Project	IEEE 802.16 Broadband Wireless Access Working Group <a href="http://ieee802.org/16">http://ieee802.org/16</a> >	
Title	Correction in PUSC Renumbering Formula	
Date Submitted	2004-09-02	
Source(s)	Sean Cai Wenzhong Zhang Jing Wang Jason Hou Jun Han Dazi Feng Irving Wang	scai@ztesandiego.com wzhang@ztesandiego.com jwang@ztesandiego.com jhou@ztesandiego.com jhan@ztesandiego.com dfeng@ztesandiego.com iwang@ztesandiego.com
	ZTE San Diego Inc. 10105 Pacific Heights Blvd. San Diego, CA 92121 USA	Voice: 858-554-0387 Fax: 858-554-0894
Re:	Response to the call for contributions to IEEE Standard 802.16-2004, IEEE 802.16maint-04/01, 2004-08-04. Header error fix to IEEE 802.16maint-04/08.	
Abstract	This contribution describes the error in PUSC cluster renumbering formula.	
Purpose	To incorporate the text modification proposed in this contribution into IEEE 802.16REVd standard.	
Notice	This document has been prepared to assist IEEE 802.16. It is offered as a basis for discussion and is not binding on the contributing individual(s) or organization(s). The material in this document is subject to change in form and content after further study. The contributor(s) reserve(s) the right to add,

Figure 1. 3-sector cell deployment

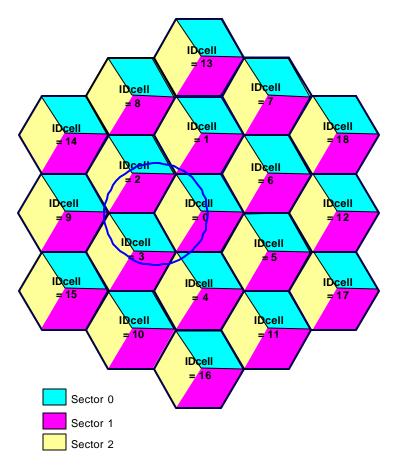
Here provided is an example of typical multiple 3-sector cell deployment, as shown in Figure 1 (circled in blue). The physical cluster numbers in red are the common physical clusters that will cause interference among these sectors.

```
Physical Clusters (Sector = 2, IDcell = 0):
     3 92 80 55 88 41 98 94 100 70 64 68
                                                    11 118 25 110 62 33 84
                                                                                 5
 66 112
Physical Clusters (Sector = 1, IDcell = 2):
                          53 43 35 18 110 51
39
    77
        100
             26
                  79
                                                  30
                                                       4 106 61 41 57
                                                                           112 63
82 27
       11
Physical Clusters (Sector = 0, IDcell = 3):
       74
                                    7 95 52 60 70 72 36 103 117 34 56 15 24
    9
           58
               78
                    3 81 107 68
113 101
```

The interference caused by the sectors with the same group numbers of different BS, typically from second tier cells (such as sector 0 of IDcell 12 BS to sector 0 of IDcell 0 BS, as depicted in Figure 1), can still be mitigated with the help of current subcarriers permutation scheme defined in the standard; sectors from different cells may have the same physical clusters however their logical subchannels can be different due to intra-group data subcarrier permutation based on different IDcell numbers.

Because of the interference caused by the renumbering formula, we propose to remove the formula, using the only default renumber sequence in *Table 308* of IEEE P802.16-REVd/D5-2004. With this change, the physical cluster assignment to the 6 cluster groups (Group 0 to 5) are fixed; all the different group number subcarrier allocation will be orthogonal to each other, with the same or different IDcell number assignment. The same example in Figure 1 (circled in blue) can be used here. There are no colliding physical clusters from different sectors.
